November 16, 2022

**RE: Dutch Brothers - Juan Tabo
Grading & Drainage Plan
Engineer's Stamp Date: 10/24/22
Hydrology File: H21D004B**

SHEET TITLE
GRADING & DRAINAGE PLAN

SHEET NUMBER
CG-101

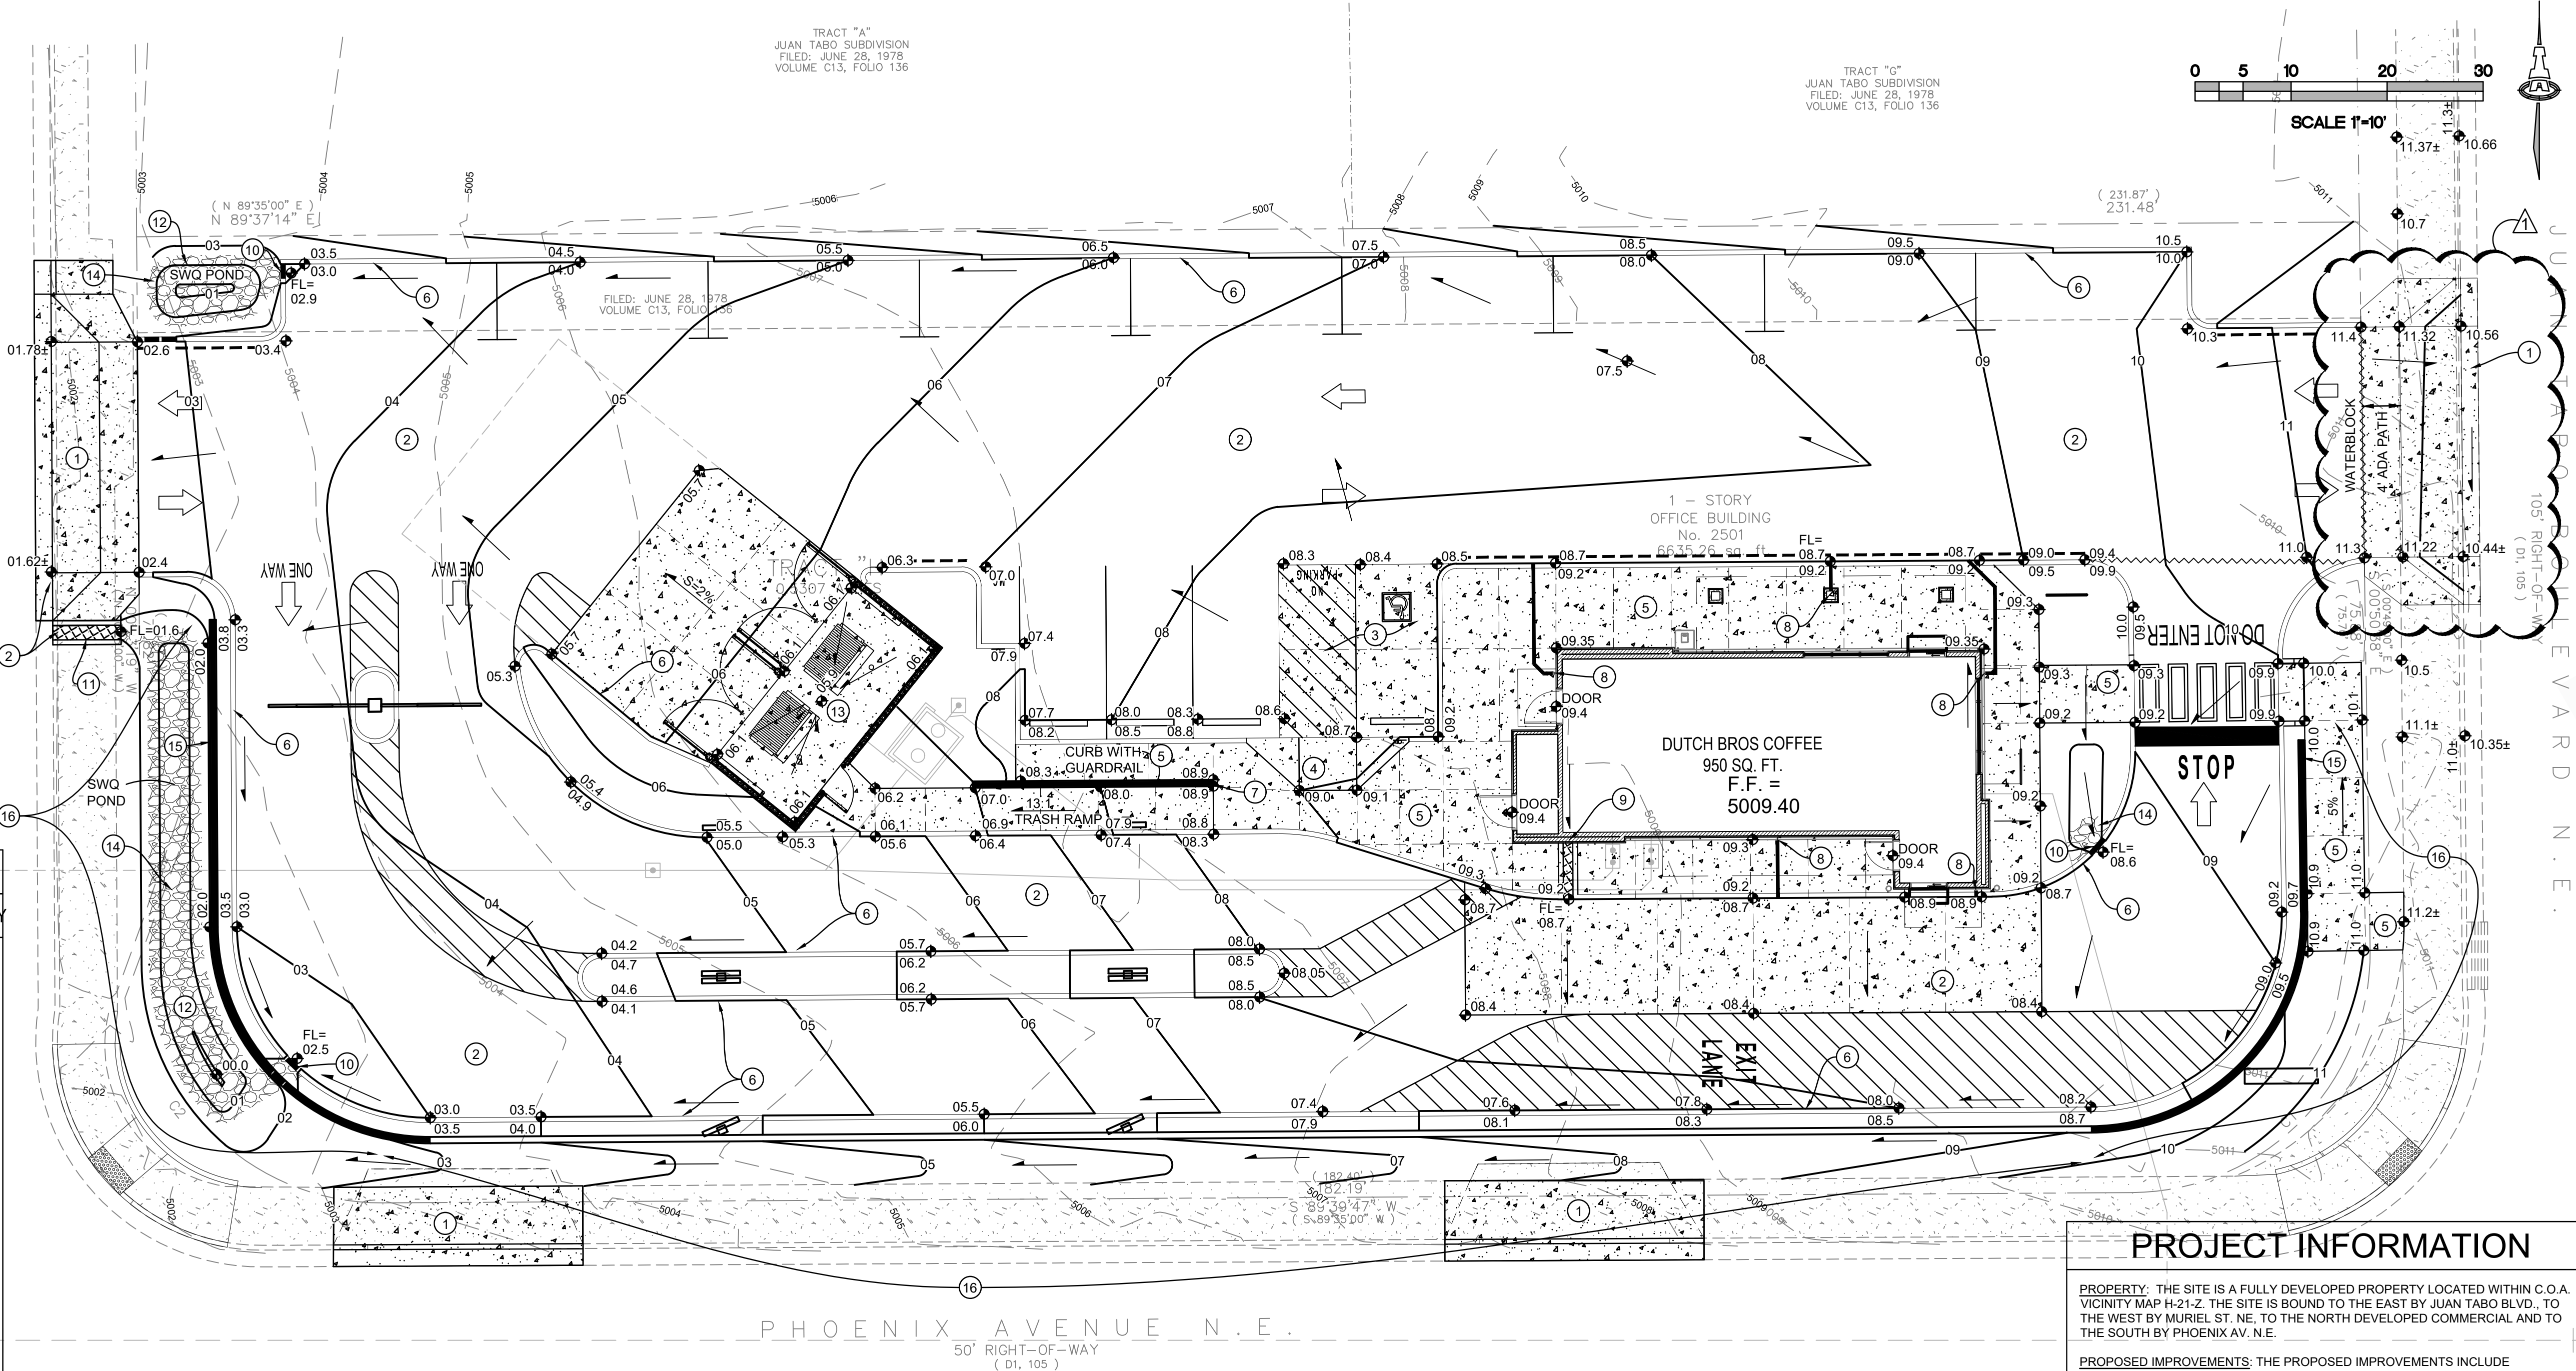
1. Engineer's Certification, per the DPM Part 6-14 (F): *Engineer's Certification Checklist For Non-Subdivision* is required.
2. Please provide the Drainage Covenant with Exhibit A for the stormwater quality ponds per Article 6-15(C) of the DPM prior to Permanent Release of Occupancy. Please submit the original copies along with the \$ 25.00 recording fee check made payable to Bernalillo County to Carrie Compton (cacompton@cabq.gov) on the 4th floor of Plaza de Sol.
3. Please pay the Payment-in-Lieu of \$ 896.00 by emailing the attached approved Waiver Application from Stormwater Quality Volume Management On-site to PLNDRS@cabq.gov. Once this is received, a receipt will then produce and email back with instructions on how to pay online. Once paid, please email me proof of payment.

Based upon the information provided in your submittal received 10/25/2022, the Grading & Drainage Plan is approved for Building Permit, Grading Permit and SO-19 Permit. Please attach a copy of this approved plan in the construction sets for Building Permit processing along with a copy of this letter.
